**RM006 Mr and Mrs Calvocoressi's objection to the Environment Agency's Application to vary the Scheme within the River Medway (Flood Relief) Act 1976**

**Environment Agency technical response, September 2020**

Figure 1: Increase in flood depth in a 1.33% flood event. 28.05m AOD vs 28.6m AOD

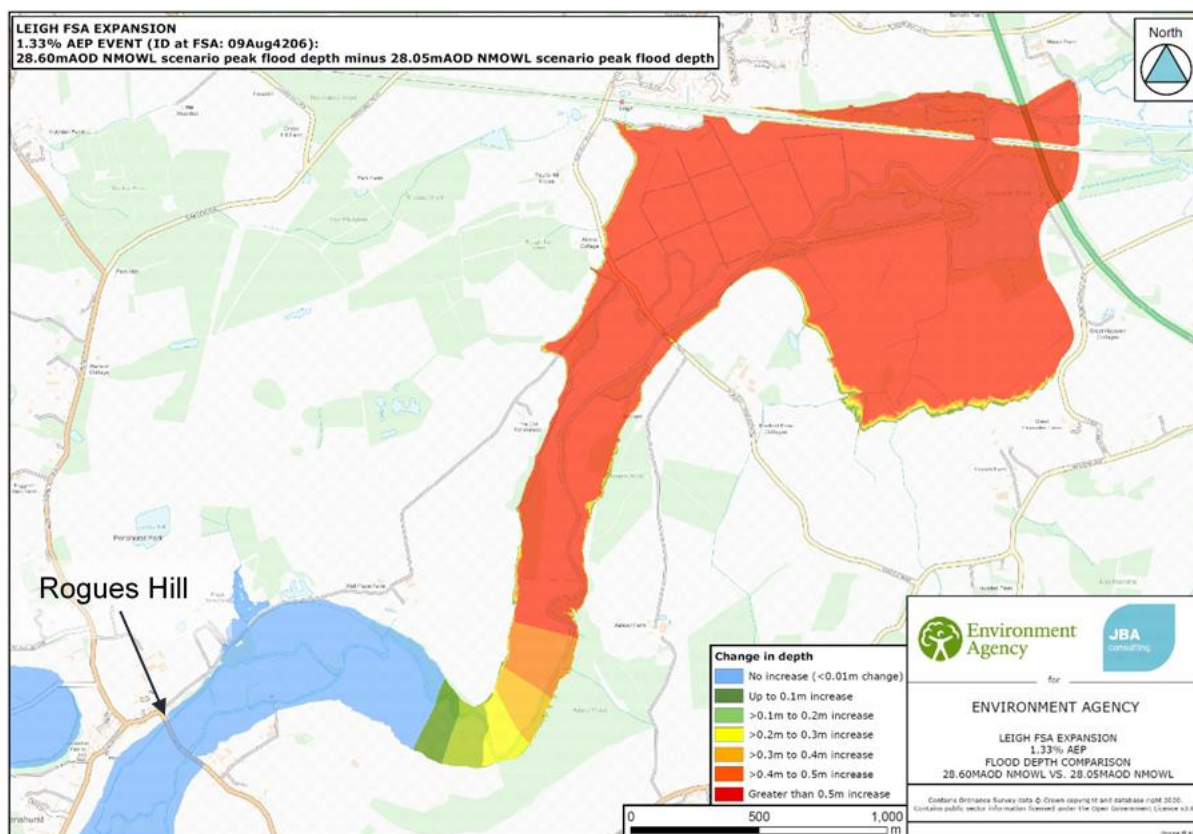
**1. Whilst it is recognised that there is a need for adjustment to the flood storage area in order to protect properties downstream we are very concerned that not enough consideration or communication has taken place with communities upstream. Most importantly, no monitoring has taken place, the safety aspects, accessibility of the village or potential effect on the community and property in Penshurst have not been properly assessed and no solutions have been proposed. Highways have not been consulted and the application is made based entirely on theoretical reports rather than real life evidence with no attempt made to verify the theory which has itself changed over time.**

**5. We know that with the proposed rise flooding will be higher and will last longer, what are the Environment Agency planning to do to mitigate the damage this will cause?**

**9. For example in the proposed scheme the environmental agency states that this scheme has a design life of 40 years, however they go on to say the flooding is 1/75 yrs, why the differential? Then on the recent planning for Bridge House they state flooding as a 1/100 year occurrence +climate change at 25% and that the new extension should be built with a 600mm freeboard, this is inconsistent. In reality though, serious flooding in the village and to Bridge House seems to be been more frequent than this with 3 significant floods in the last 10 years alone.**

Our modelling indicates that the proposal to increase the maximum impoundment level will not increase the depth of flooding above Rogues Hill. This is demonstrated in Figure 1 below. Figure 1 shows the increase in flooding depth from raising the Leigh FSA maximum impoundment level from 28.05m Above Ordnance Datum (AOD) to 28.6m AOD (measured at the main Leigh FSA embankment) during a 1.33% flood event. For consistency, the map below has been taken from the Flood Risk Assessment which accompanies the planning application. This map has been updated since the submission of the Application. Whilst it shows greater depth variation lower in the FSA, the point at which the effect of the expansion dissipates remains the same.

Every flood event is different, depending on a number of factors, including soil saturation and weather patterns. The modelled scenario in Figure 1 was chosen to demonstrate the impact of expanding the FSA because it shows the greatest change in flood depths.

As noted in Figure 1, depending on the size of the event, the proposed changes will increase the depth of flooding at the Leigh end of the FSA, but this effect dissipates toward the upper end of the FSA (downstream of Rogues Hill).

Figure 1 in our response to your first point shows a plan of the additional depth of water during a modelled 1.33% (1 in 75 year) flood event as a result of changing the maximum stored water level from 28.05m AOD to 28.6m AOD.

We chose this scenario to demonstrate the impact of expanding the FSA because it shows the greatest change in flood depths as a result of the proposed change. The depth increase for the majority of the storage area will be greatest for the 1.33% event.

During more extreme flood events, such as a 1% (1 in 100 year) plus climate change event, the increase in depth as a result of the proposed change reduces. This is because the natural flood level, which is greater, dominates.

*Figure 2: Flooding of Rogues Hill in 1937*

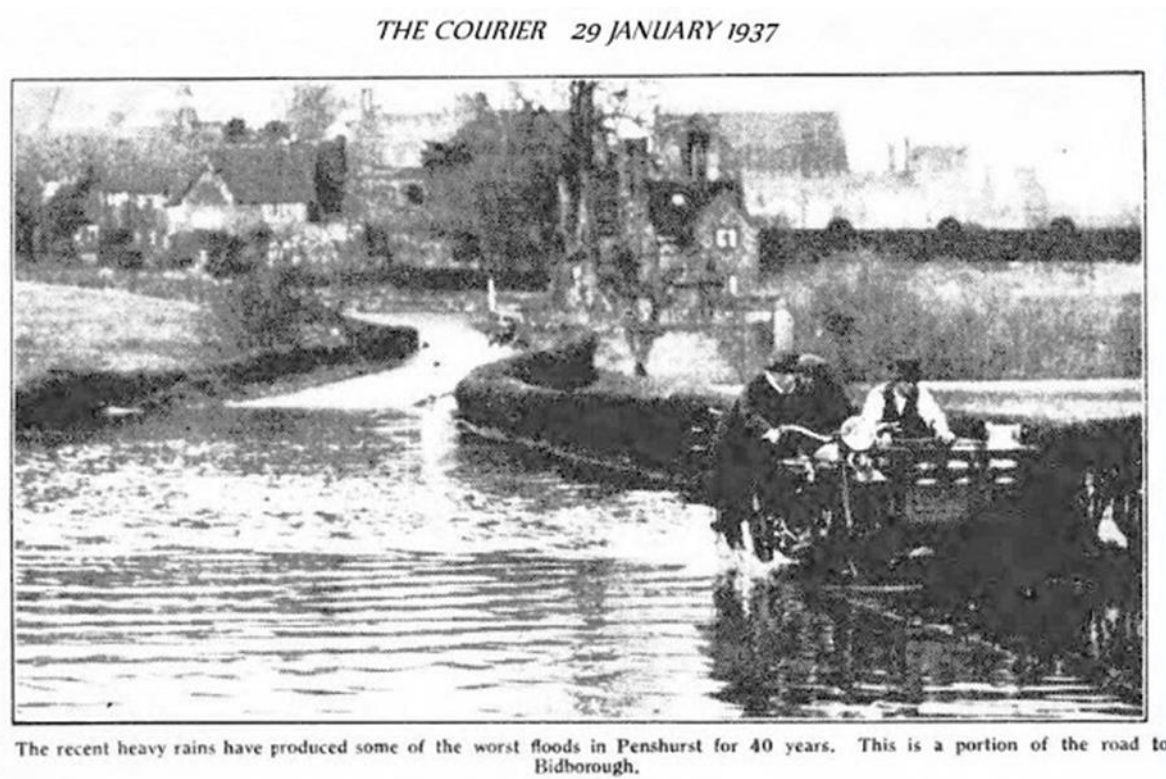
**2. We challenge the EA's assumptions on 'natural flooding'. We do not believe their parameters and assumptions.- In our experience as residents of the village, flooding is greater and lasts for longer when the barrier is shut, so to claim the barrier doesn't affect the village or our property is simply incorrect.**

However, there are historical reports of flooding in Penshurst which occurred prior to the construction of the FSA, demonstrating that the area is affected by natural flooding. Indeed, the FSA itself was constructed in response to the 1968 flood when the flooding at Rogues Hill was so severe that the road bridge over the River Medway was damaged and a temporary bridge had to be installed. The photograph below from a newspaper article (Figure 2) shows flooding on Rogues Hill in 1937. These events demonstrate that Rogues Hill was vulnerable to flooding prior to the construction of the FSA.
